Access Compliance Report

Public Rights-of-Way

(Curb Ramps)

Intersection ID: 31225	Main Street: CLACKWYCK_LN	Cross Street: GRANTHAM_LN	Location:	N
ADA ID: A3BA53BADCA2	Ramp Type: PerpDiag	Initial Pass/Fail: Fail	Overall Compliance: No	Severity Score: 42.5
Codes/Mitigation Info/Possible Solution		Field Measurements/Component Compliance

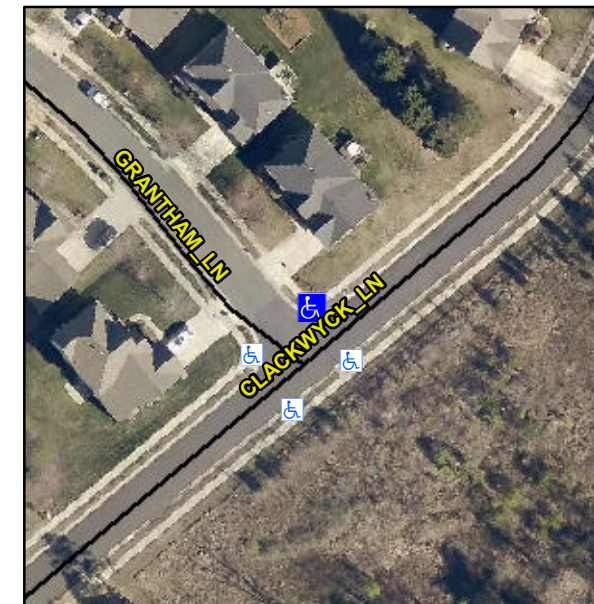
Not Found, R304.5.1, R304.5.3

Compliance	Description	Data	Compliance	Description	Data
N/A	Ramp Length (in)	48.0	Yes	Ramp Slope (%)	5.1
No	Ramp Width (in)	35.0	No	Ramp XSlope (%)	8.6
N/A	Flare Type LT	N/A	N/A	Flare Type RT	N/A
N/A	Flare Slope LT (%)	N/A	N/A	Flare Slope RT (%)	N/A
N/A	Flare Traversable LT?	N/A	N/A	Flare Traversable RT?	N/A
N/A	Landing Length (in)	N/A	N/A	DWS Provided?	N/A
N/A	Landing Width (in)	N/A	N/A	DWS Contrast?	N/A
N/A	Landing Slope (%)	N/A	N/A	DWS Length (in)	N/A
N/A	Landing X Slope (%)	N/A	N/A	DWS Full Width?	N/A
N/A	Landing Curb? (Y/N)	N/A	N/A	DWS Offset (in)	N/A
N/A	Shared Landing?	N/A			
N/A	Gutter Ponding?	N/A	N/A	Gutter Slope (%)	N/A
N/A	Gutter Lip Ht (in)	N/A	N/A	Gutter X Slope (%)	N/A
N/A	Painted X Walk1?	No	N/A	Painted X Walk2?	No
	X Walk 1 Direction	To SW		X Walk 2 Direction	To SE
N/A	X Walk 1 Width (in)	N/A	N/A	X Walk 2 Width (in)	N/A
	X Walk 1 Slope (%)	6.3		X Walk 2 Slope (%)	4.3
	X Walk 1 X Slope (%)	5.7		X Walk 2 X Slope (%)	6.2

N/A	Ramp inside XWalk1?	N/A	N/A	Ramp inside XWalk2?	N/A
	Road Slope (%)	6.5	N/A	Clear Space?	N/A
	Road X Slope (%)	4.9	N/A	Clear Space to XWalk (in)	N/A
N/A	Any Obstructions?	N/A	N/A	Storm Grate/Utility Hazard?	N/A
	Obstruction Type			Storm Grate/Utility Type	
		N/A			N/A
			Yes	Surface Condition? (G/P)	Good

Remove & Replace Curb Ramp With Two New Directional Ramps or Equivalent.
